ORIGINATION FORM

Proposed Revisions to a Standard Plans Index

Index Number: 443-001

Index Title: French Drain

FRENCH DRAIN ASSEMBLY

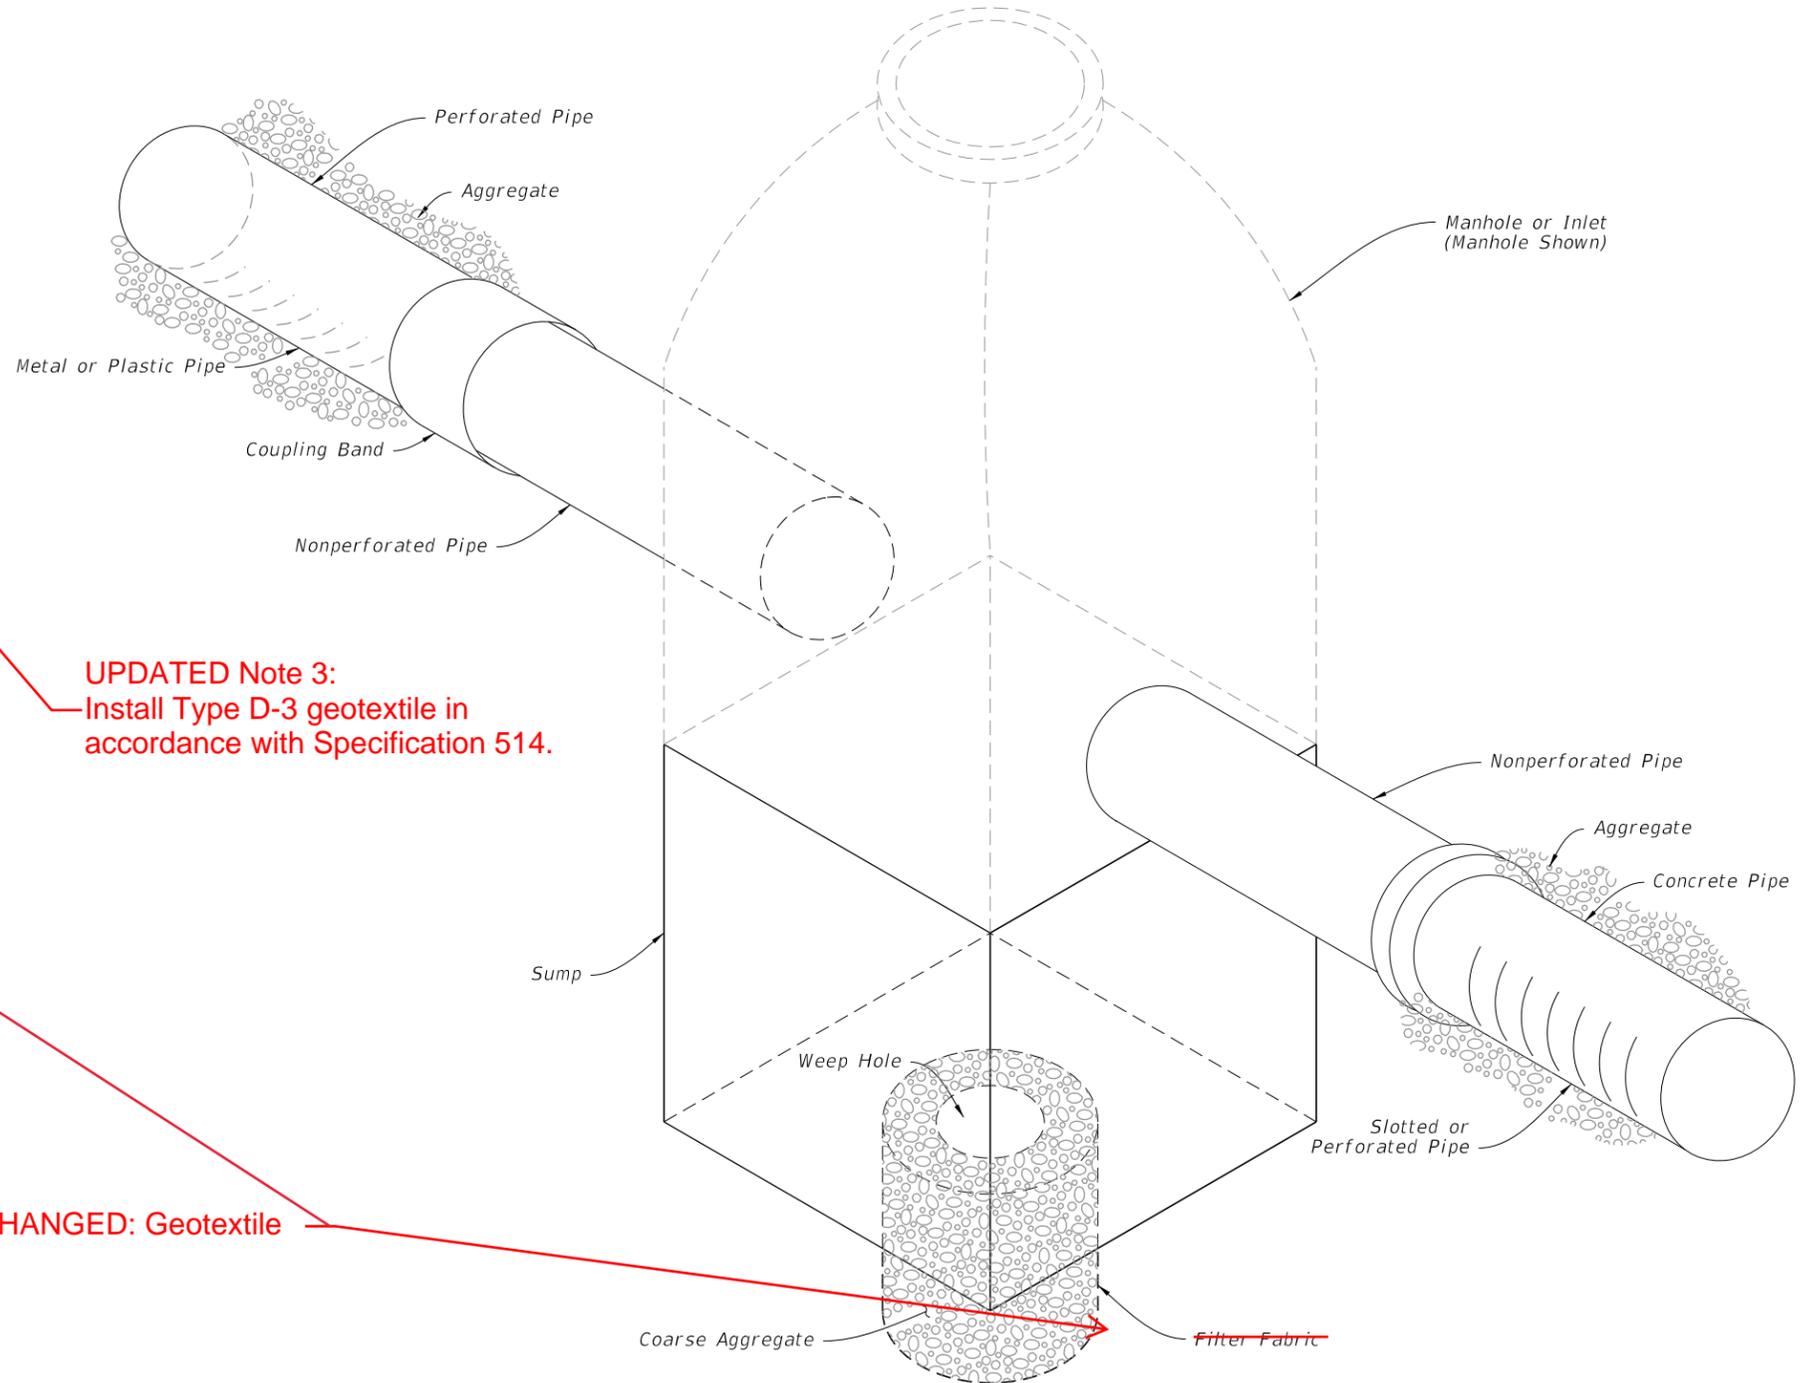
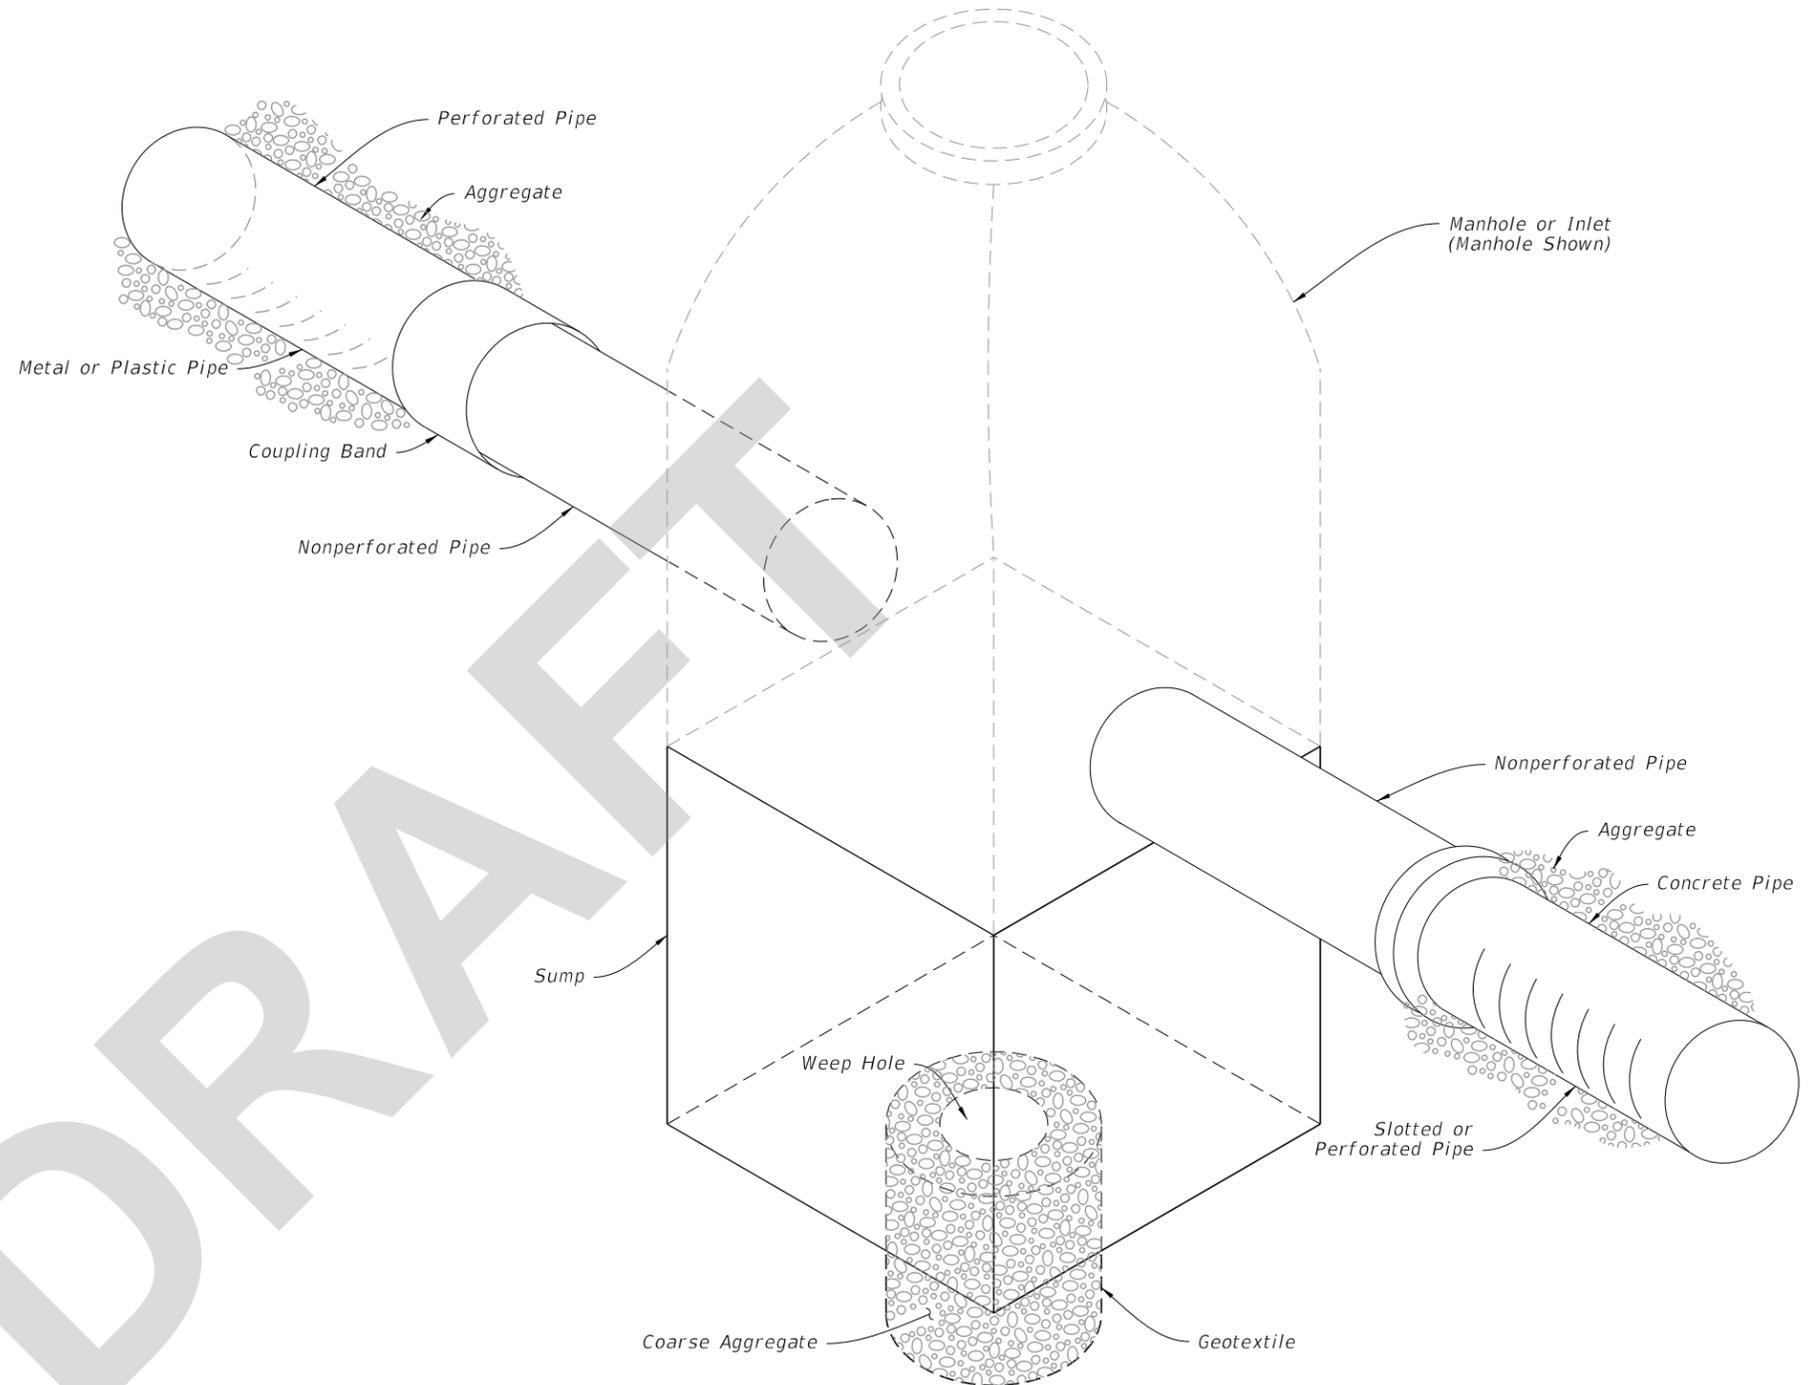
Sheet 1: Updated GENERAL NOTE 3 "Install Type D-3 geotextile in accordance with Specification 514."; Changed all references of "Filter Fabric" to "Geotextile".

1. Place concrete pipe with the slots positioned on sides.
2. Alignment joints are standard (gaskets not required). Recorrugation of metal pipe ends not required.
3. ~~Install Type D-3 filter fabric in accordance with Specification 985. Lap all filter fabric joints a minimum of one (1) foot.~~
4. Construct the standard cross section unless other section(s) described or detailed in the plans.
5. See Index 430-001 for supplemental details.
6. Take the necessary precautions to prevent contamination of the trench with sand, silt and foreign materials.

UPDATED Note 3:
Install Type D-3 geotextile in accordance with Specification 514.

CHANGED: Geotextile

1. Place concrete pipe with the slots positioned on sides.
2. Alignment joints are standard (gaskets not required). Recorrugation of metal pipe ends not required.
3. Install Type D-3 geotextile in accordance with Specification 514. Lap all geotextile joints a minimum of one (1) foot.
4. Construct the standard cross section unless other section(s) described or detailed in the plans.
5. See Index 430-001 for supplemental details.
6. Take the necessary precautions to prevent contamination of the trench with sand, silt and foreign materials.

FRENCH DRAIN
(Round Pipe Shown)

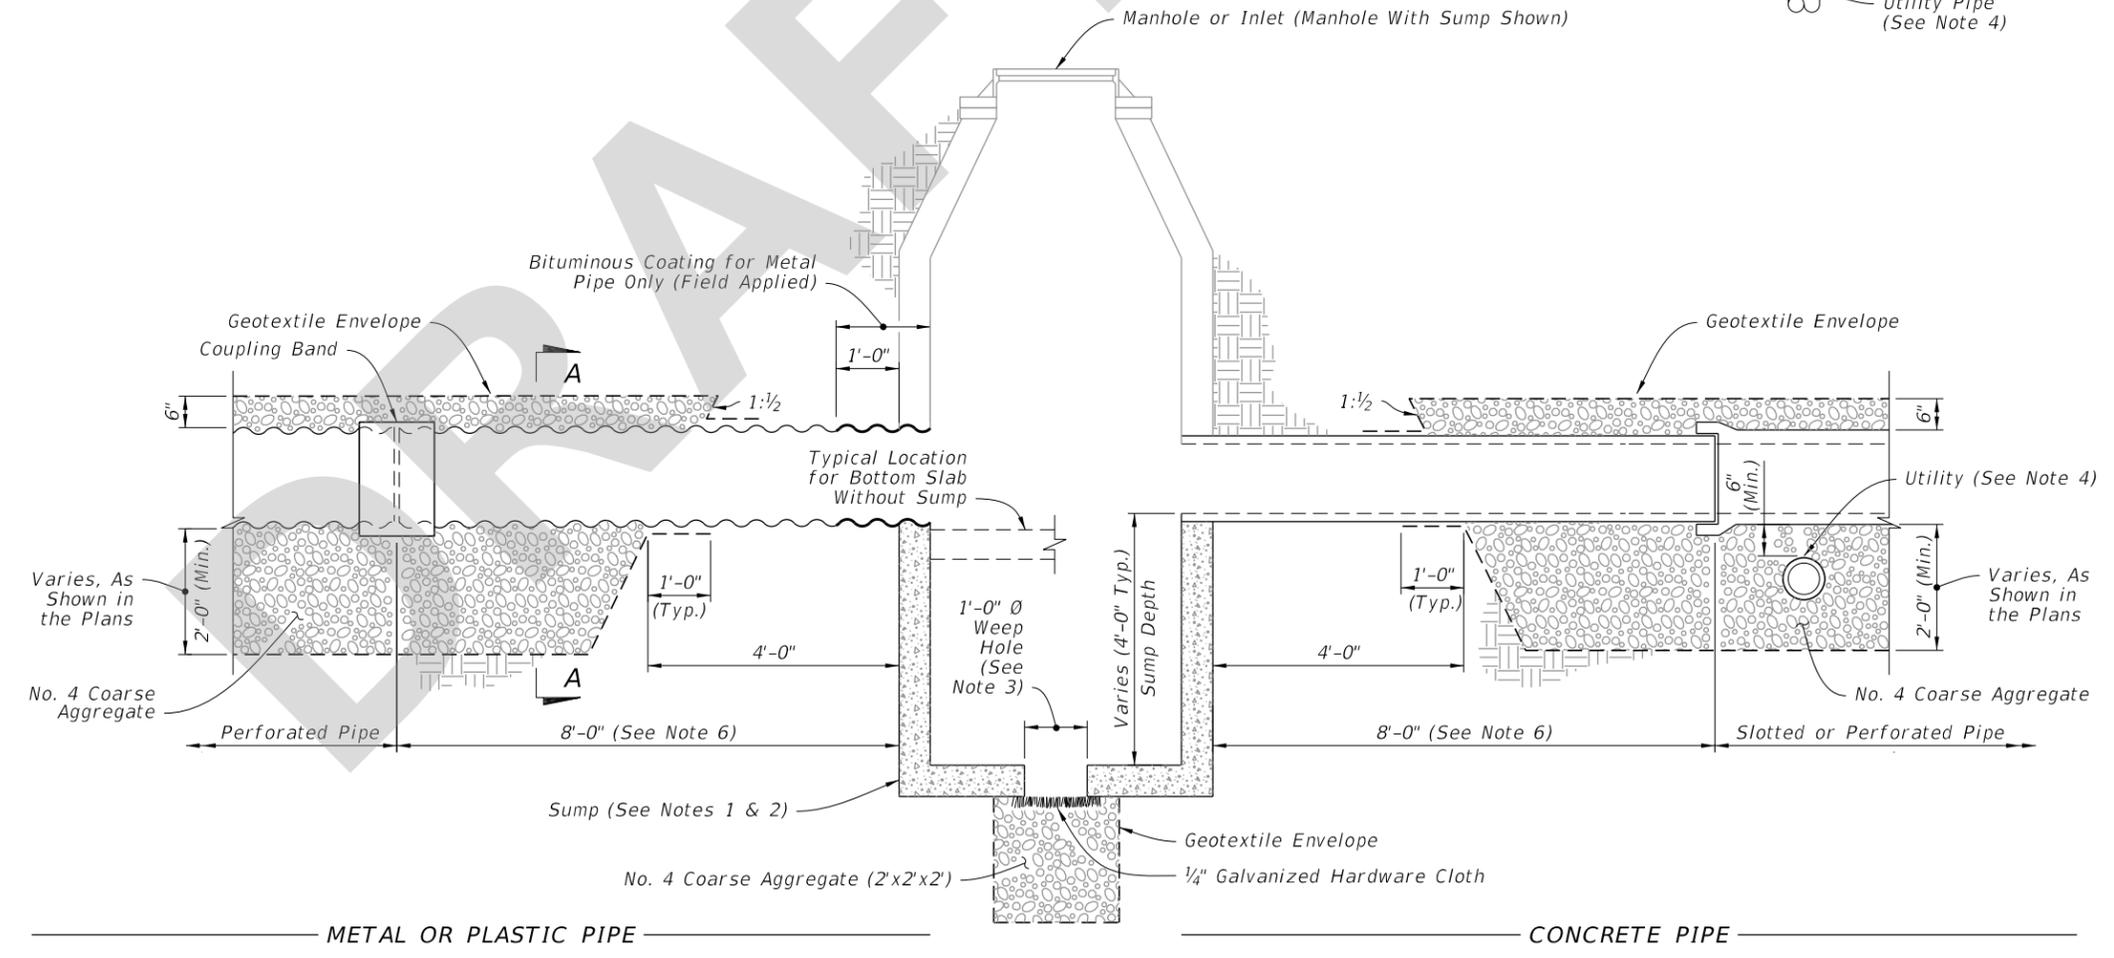
Sheet 2: Changed all references of "Filter Fabric" to "Geotextile".
